Architect's Supplemental Instructions

Architect's ASI No: 047

Project:
Webster University
Interdisciplinary Science
Building

SHEET E0101.A LEVEL 01 AREA A FLOOR PLAN – ELECTRICAL & AUXILIARY

E0101.A

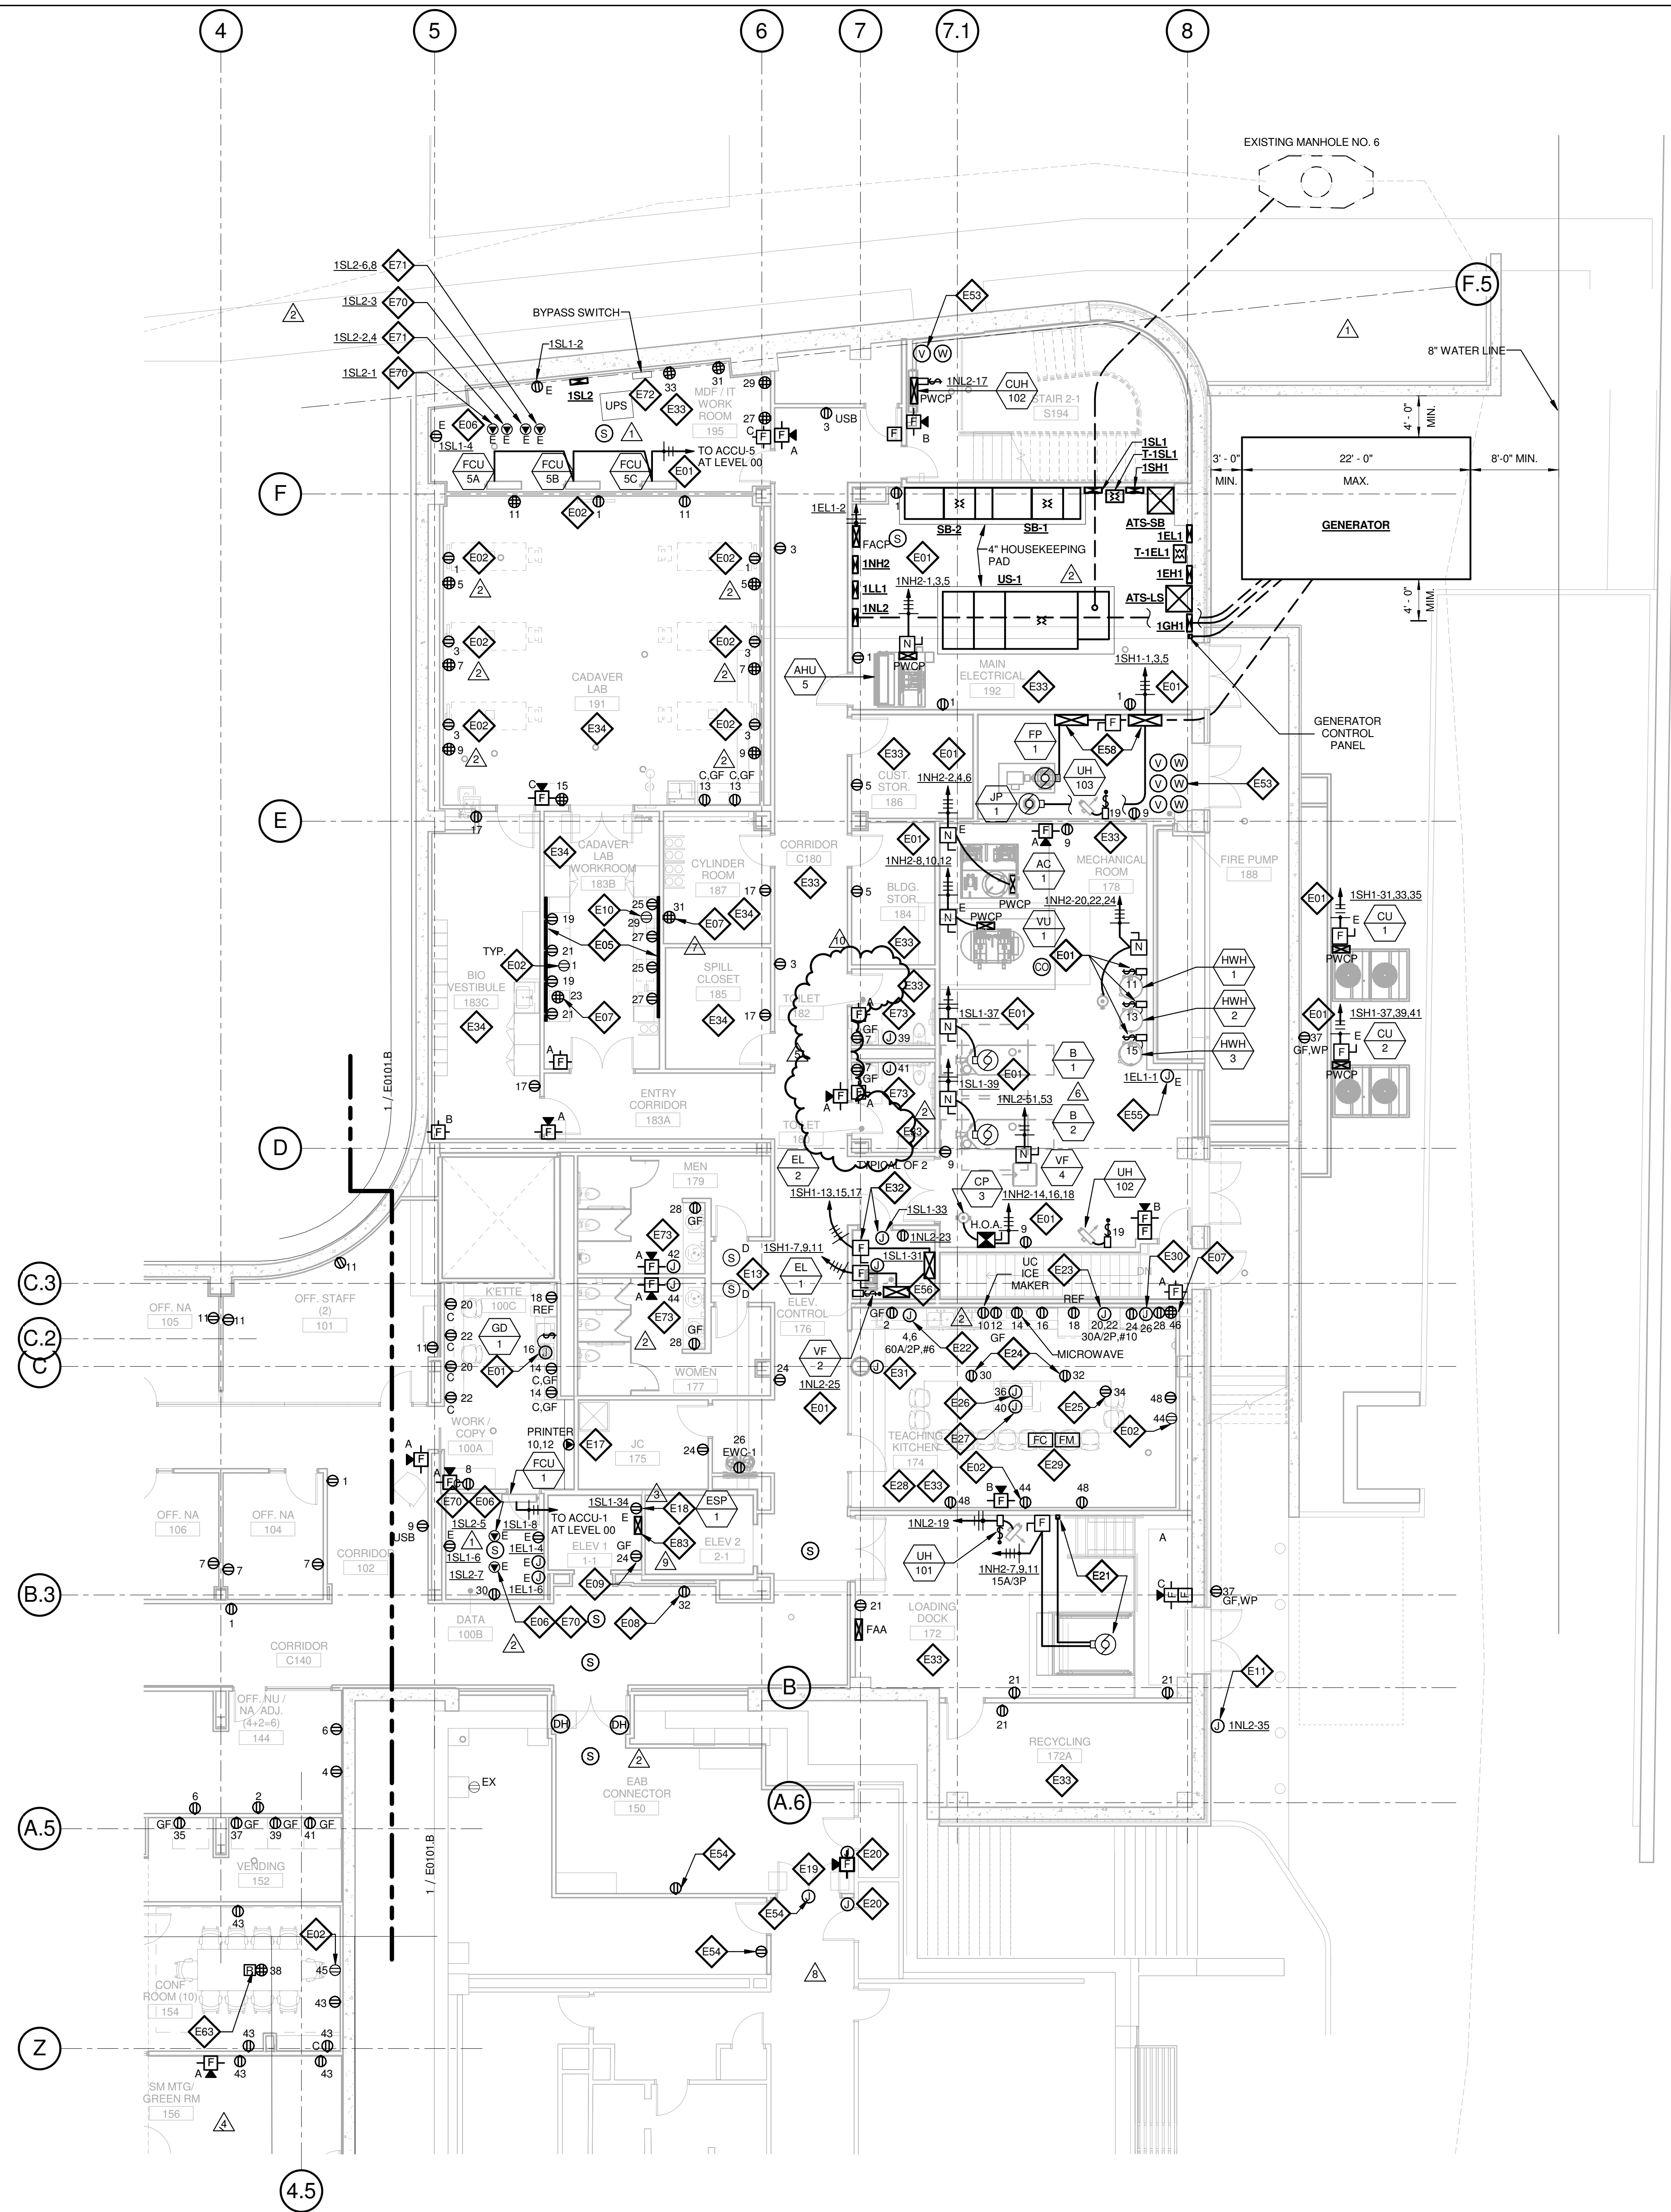
- In Rooms 180 and 182, remove power and final connections for two door openers per room and associated Keyed Note E19.
- In Rooms 180 and 182, remove power and final connection for door opener controls and associated Keyed Note E20.

E0102.A

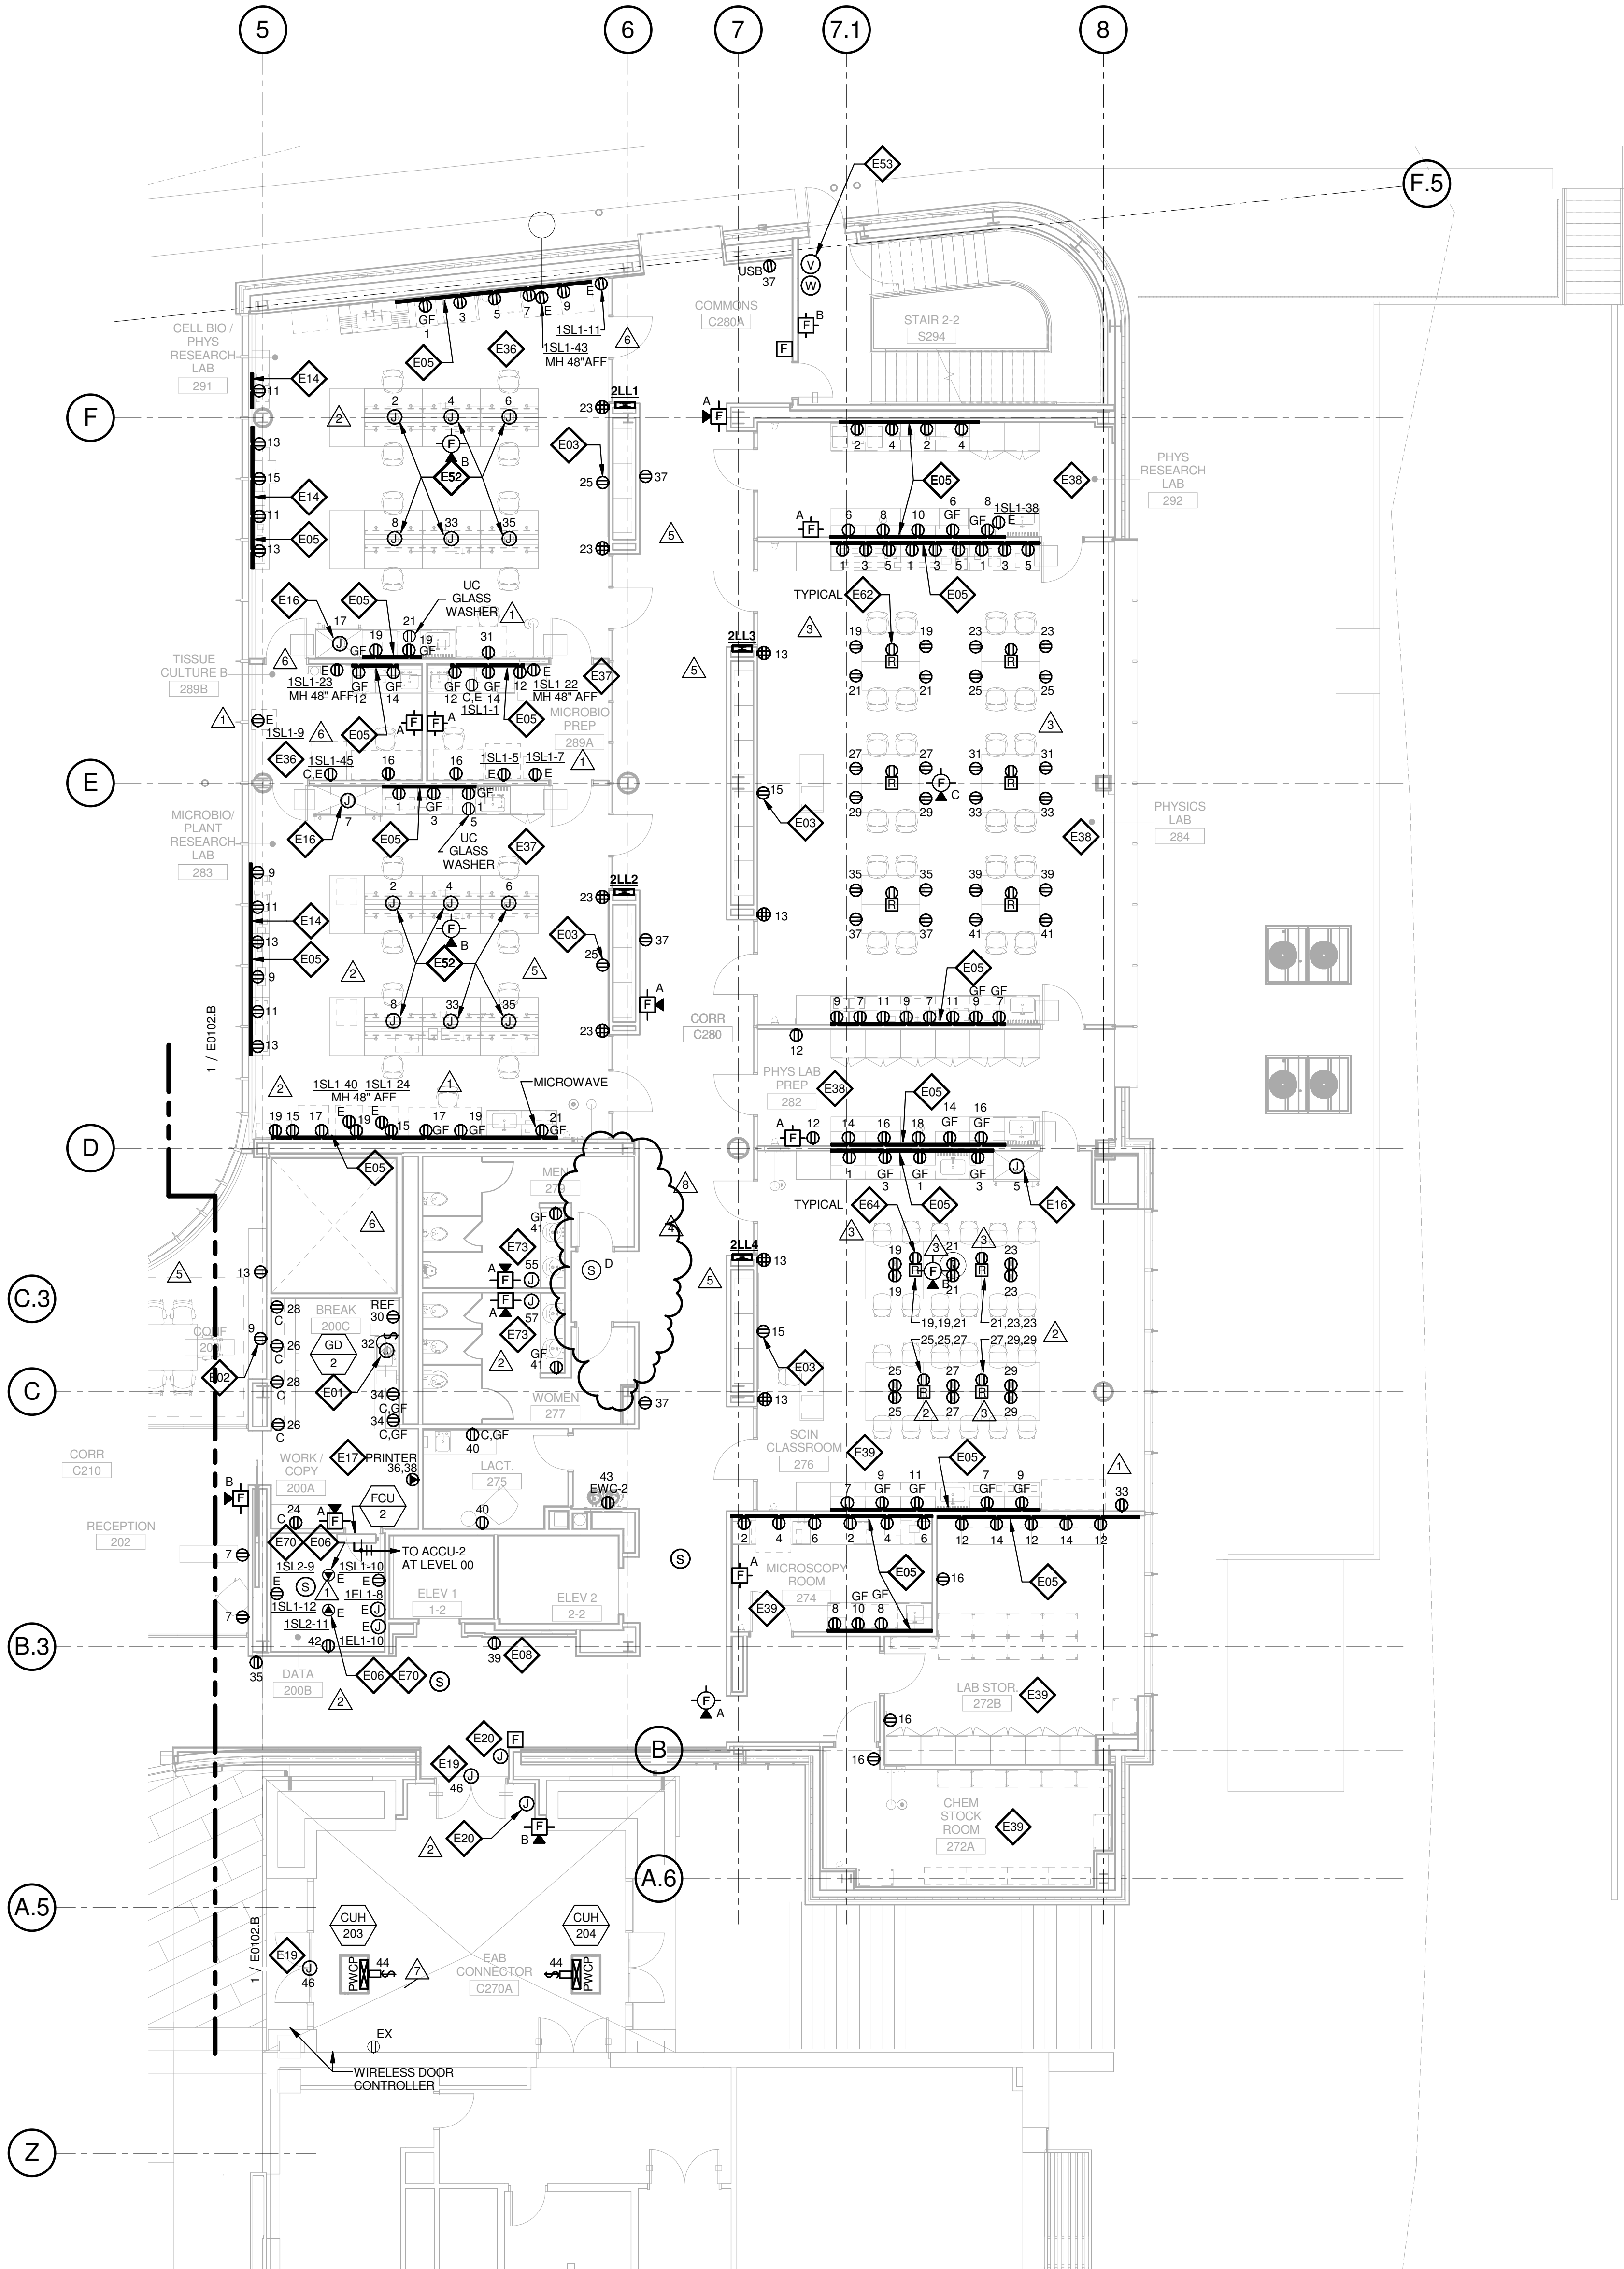
- In Rooms 277 and 279, remove power and final connections for two door openers per room and associated Keyed Note E19.
- In Rooms 277 and 279, remove power and final connection for door opener controls and associated Keyed Note E20.
